Contract #: 04-0120F4Cty: SF/ALA Rte: 80 PM: 13.2/13.9File #: 69.25B**QUALITY ASSURANCE -- NON-CONFORMANCE REPORT****Location:** Changxing Island, Shanghai, P.R. China**Report No:** NCR-000515**Prime Contractor:** American Bridge/Fluor Enterprises, a JV**Date:** 13-Nov-2009**Submitting Contractor:** Zhenhua Port Machinery Company, Ltd (ZPMC), Changxing Island**NCR #:** ZPMC-0488**Type of problem:**

Reference Description: T-stiffener Web Flatness, OBG Segment 5BW, Side Panel, Crossbeam Side**Description of Non-Conformance:**

Subject: NCR No. ZPMC-0488

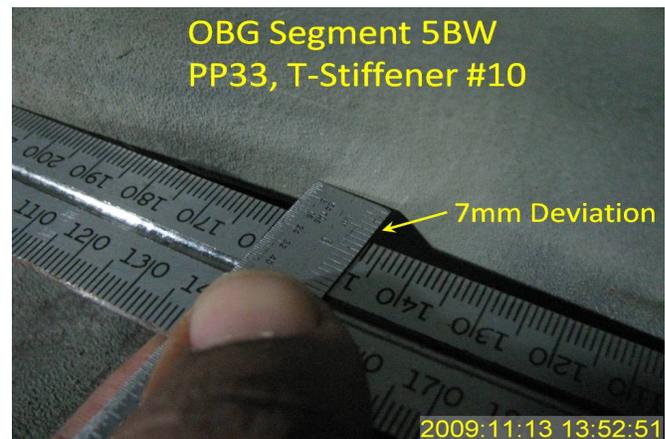
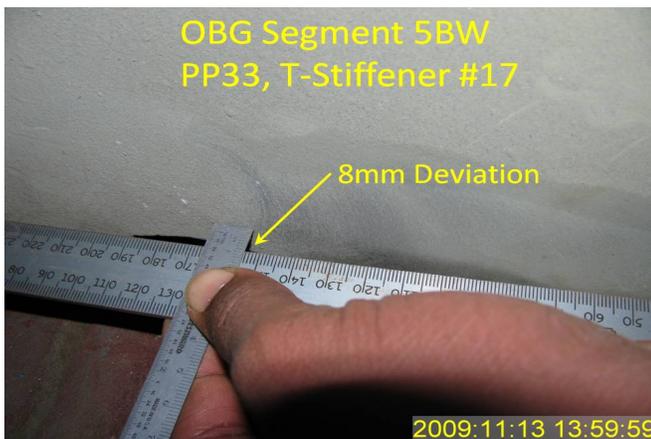
During dimensional inspection of OBG Segment 5BW, Caltrans Quality Assurance (QA) observed out-of-tolerance flatness on the webs of side panel T-stiffeners at Panel Point PP33 (crossbeam side). The flatness measurements were taken using a 300mm straight edge conforming to the requirements of AASHTO section 11.4.13.1. The following deviations were observed:

7mm at stiffener #10 (from working point W4)

8mm at stiffener #17 (from working point W4)

The maximum allowable deviation from detailed flatness is 5mm.

Repair damage according to the approved retrofit RFI to be submitted by ABF.

Reference Description: T-stiffener Web Flatness, OBG Segment 5BW, Side Panel, Crossbeam Side

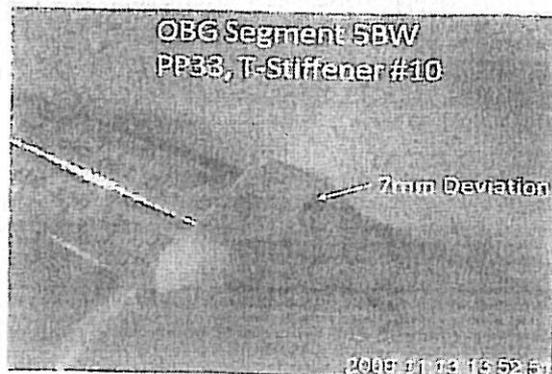
During dimensional inspection of OBG Segment 5BW, Caltrans Quality Assurance (QA) observed out-of-tolerance flatness on the webs of side panel T-stiffeners at Panel Point PP33 (crossbeam side). The flatness measurements were taken using a 300mm straight edge conforming to the requirements of AASHTO section 11.4.13.1. The following deviations were observed:

- 7mm at stiffener #10 (from working point W4)
- 8mm at stiffener #17 (from working point W4)

The maximum allowable deviation from detailed flatness is 5mm.

Draft of welding discontinuity:

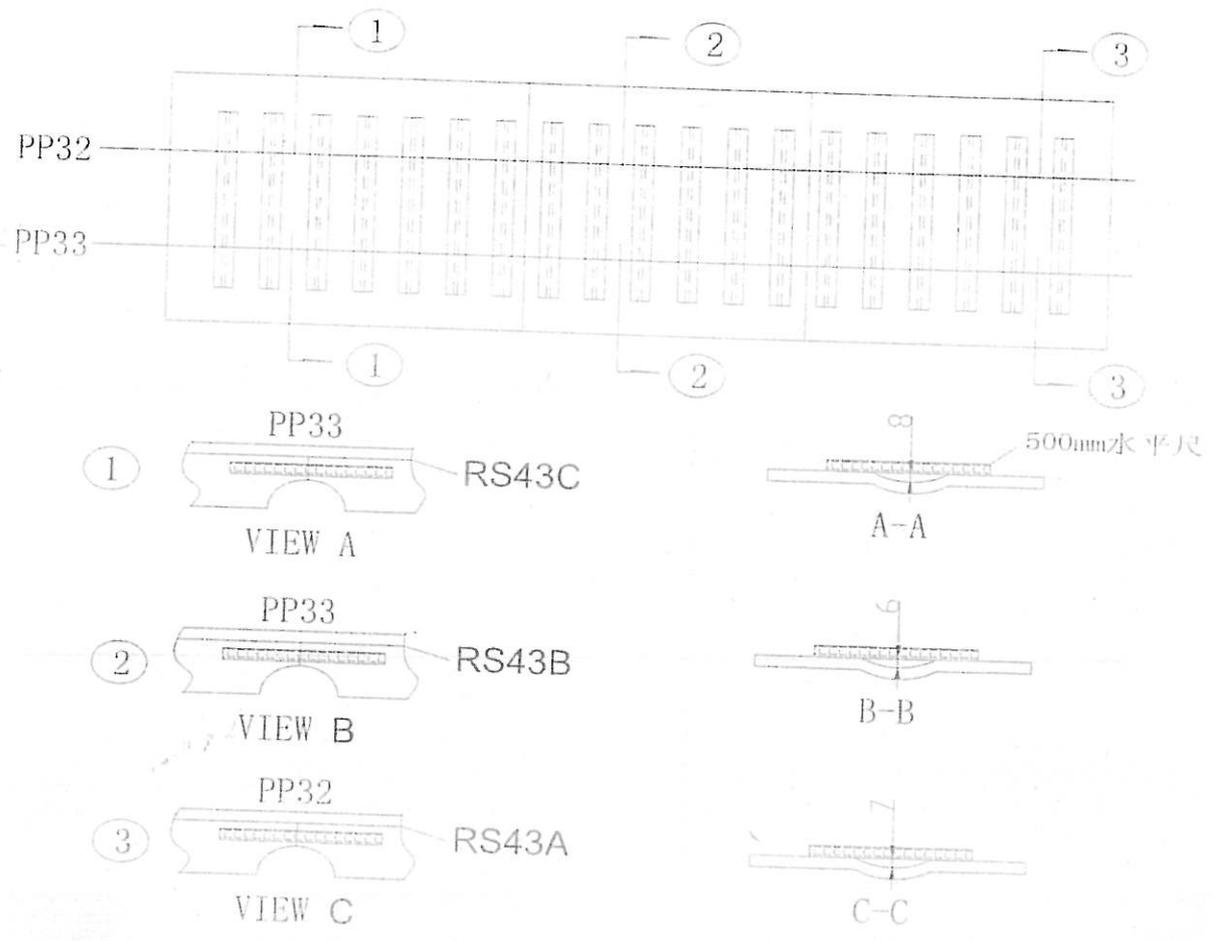
5BW 斜底板近联系梁侧, T 肋连接板螺栓拧紧后, 测量 T 肋筋板平整度。发现 pp32, pp33 处 T 肋筋板平整度超标, 最大 8mm, 具体数据见附页:

After bolt T-rib connect plate at 5BW side plate face strut plat, the flatness exceeded requirement, maximum 8mm, the detail sees the following attachment.

1. 采用碳刨或切割的方法去除上述平整度超标的 T 肋腹板与斜底板的焊缝。碳刨前根据返修 WPS 进行个预热;
2. 火工校正 T 肋腹板使其平整度满足平整度要求后, 将 T 肋腹板与斜底板点焊定位;
4. 根据批准的返修 WPS 进行预热、焊接;
5. 焊后将焊接区域打磨光滑;
6. 根据图纸要求对焊缝进 NDT 检测;

1. Remove the welds between distorted web plates of T-Ribs mentioned above and SP by gouging or flame cutting. Preheat according to approved WPS.
2. Heat straighten those distorted web plates to make their flatness meet requirement, then tack weld them to SP.
3. Preheat and weld in accordance with approved WPS.
4. Grind the area to a smooth finish.
5. Perform relevant NDT inspection to the welds according to work drawings.
